SR 520, I-5 to Medina: Bridge Replacement and HOV Project NEPA/SEPA Environmental Reevaluation: Portage Bay Bridge to I-5 Design Refinements

**23 CFR §771.129
Washington State Department of Transportation/Federal Highway Administration**

Attachment 1

Description of Changed Conditions and Effects

Project Features

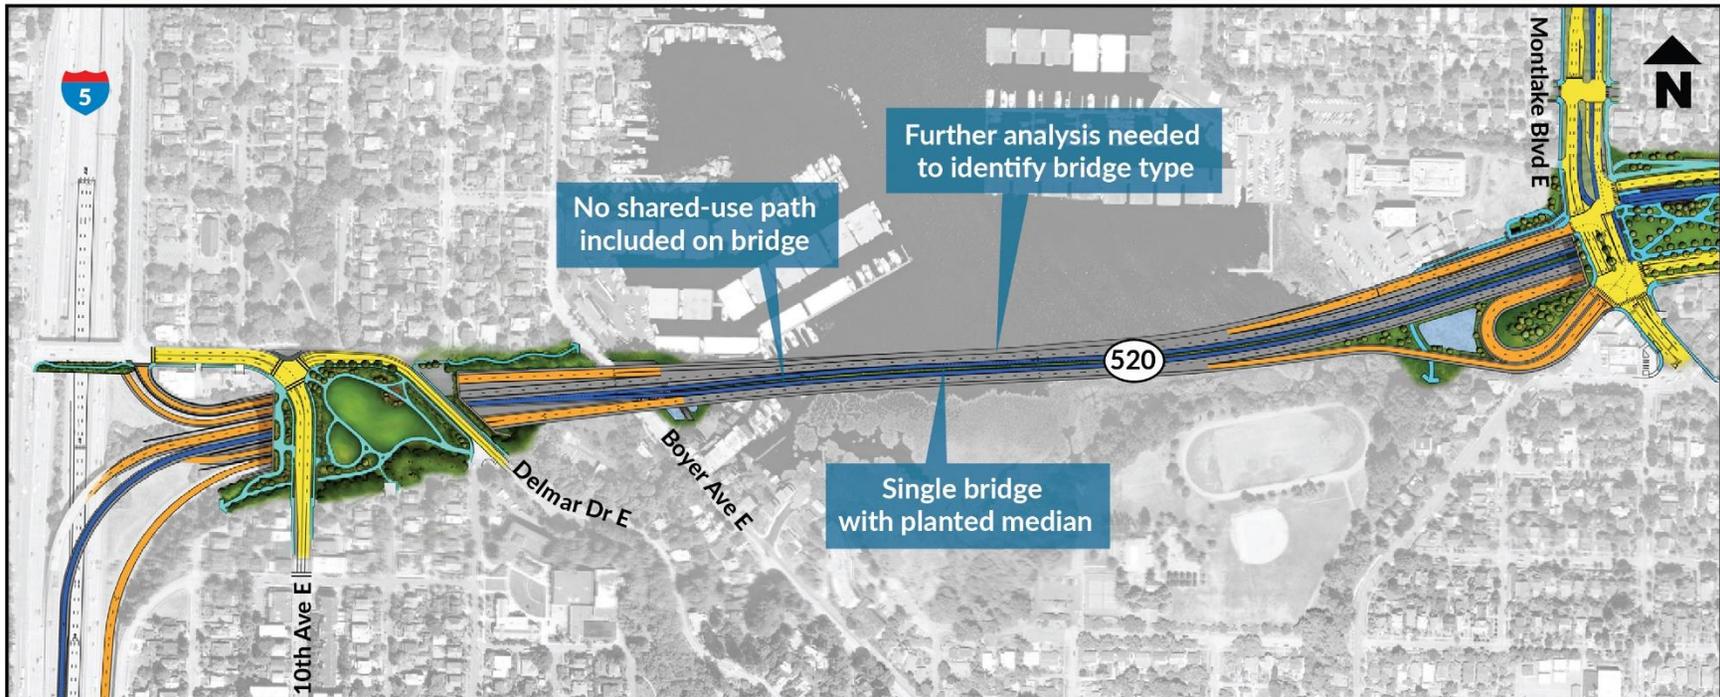
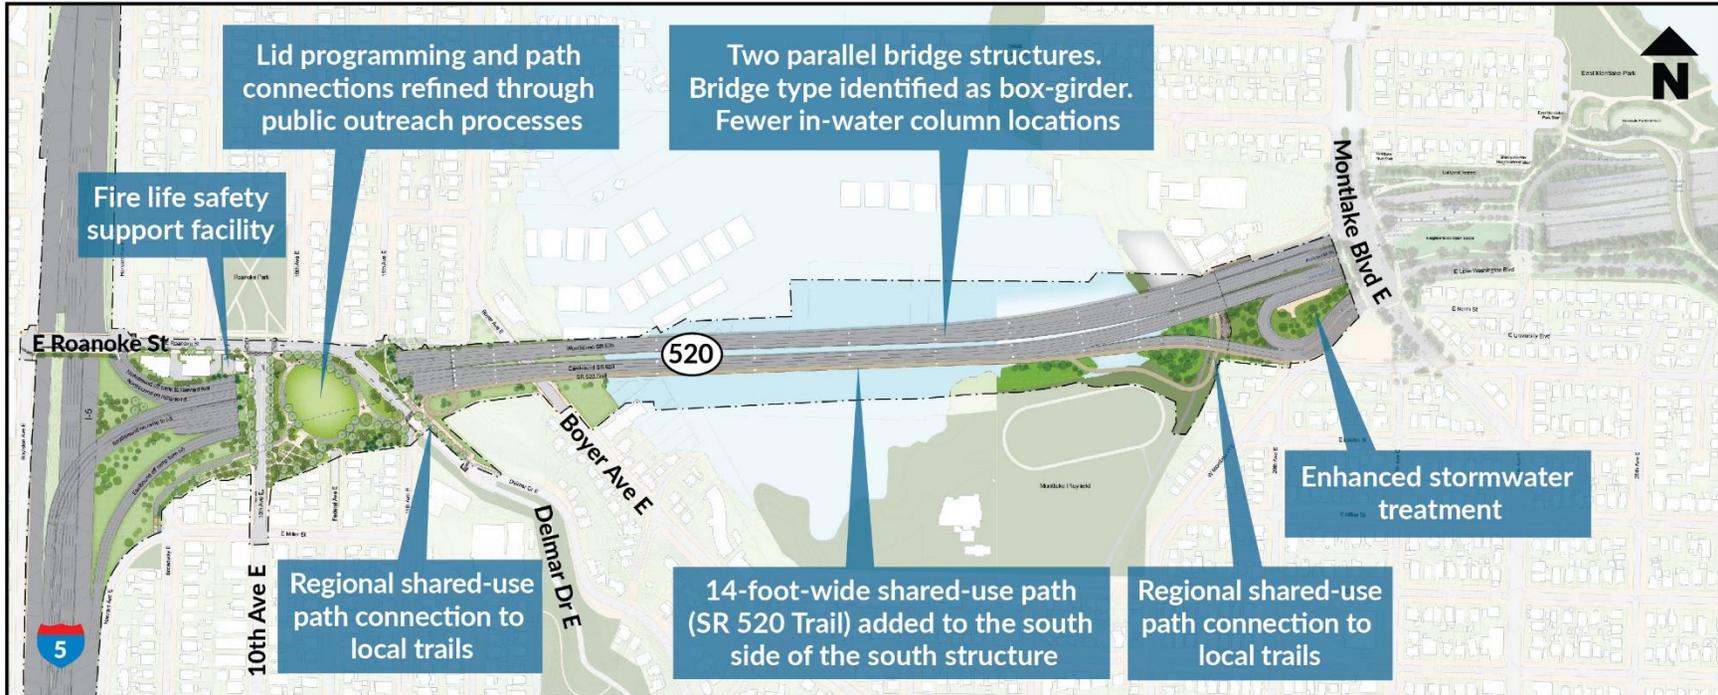
- The bridge configuration has changed from a single wide bridge with median to two parallel bridge structures.

- The Final EIS did not define the bridge type. The bridge design was established through the Seattle Community Design Process (SCDP) as a haunched box girder design with variable width gap of approximately 6 to 19 feet added between the north and south structures; pre-stressed girders will be used in the final two easternmost bays.

- The bridge alignment has been shifted to the north at the west end by approximately 35 feet to allow the westbound lanes of the new bridge to be constructed while maintaining traffic in both directions on the existing SR 520 Portage Bay Bridge. The newly constructed westbound sections of the bridge would be wide enough to accommodate moving both direction of SR 520 traffic onto the new construction while the existing bridge is removed and the new eastbound lanes of the bridge are constructed. This alignment and staging change would eliminate most of the previously planned temporary widening of the existing bridge structure and reduce the amount of temporary access trestle. This shift simplifies constructability and construction phasing by minimizing falsework and temporary work bridges. This simplified process would reduce the number of construction stages, the length of the construction period, and shorten the period of construction impacts. Also, the more northerly alignment provides space to the south to add the regional shared use path within planned right of way.

A number of changes to the design of Portage Bay Bridge would result in changes to the appearance of the bridge. See exhibit 1 for a visual simulation of the revised design. Rather than a single wide bridge with a median, the bridge would be two parallel bridge structures; the alignment of the bridge would be shifted approximately 35 feet to the north at the west end; the grade of the bridge would be changed from varying between 0.5 and 5 percent to a constant 2.6 percent grade; and the number of in-water piers and columns has been reduced from 50 to 42. The design changes were made through public consultation to reduce the visual impact of the bridge (see discussion in the Seattle Community Design Process section of this reevaluation). These changes would slightly change the appearance of the bridge itself; however, the overall appearance of the bridge in the existing environment would remain unchanged.
